**DRAWING AMENDMENTS**

Serialno: 09/441, 537  
Replacement Sheet

FIG.1 (Prior Art)

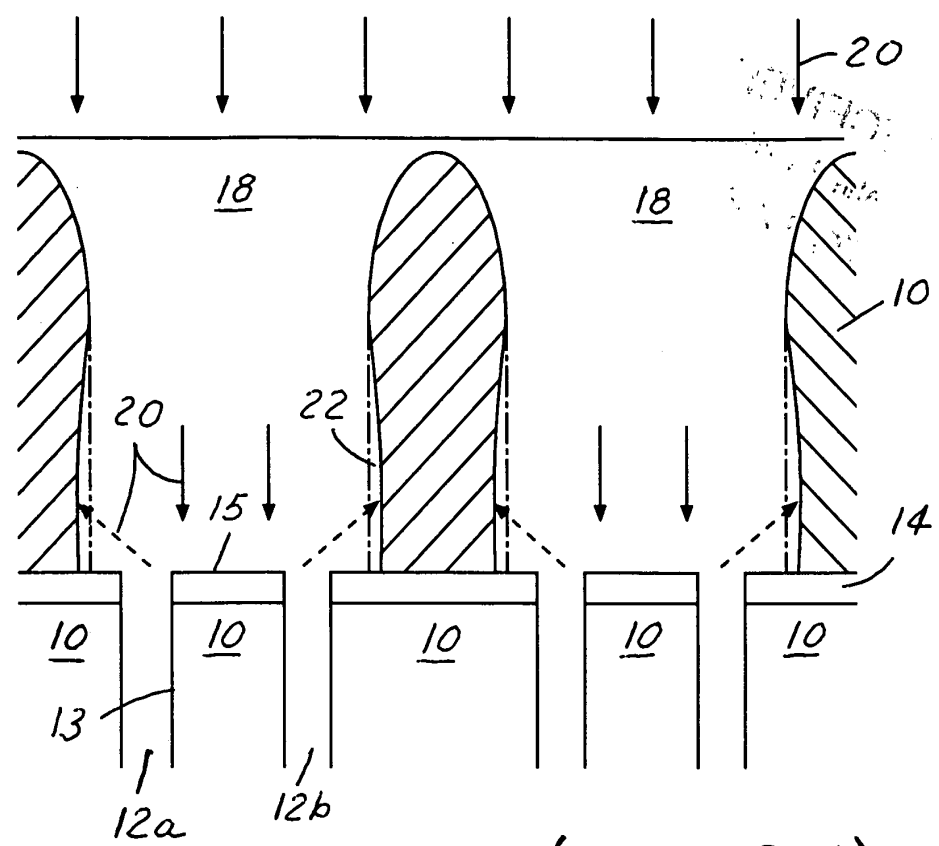
The drawings have been amended to address Examiners noted errors. In Figure 1, a 'prior art designation has been added and the resist layer renumbered 16. In Figure 3, the trench opening has been renumbered 39 and the resist layer has been renumbered as 37 to avoid redundant numbering. The First ARC layer has been shown and designated as 36 to be consistent with the Specification and consistent with the structure and designation number 26 shown in Figure 2.
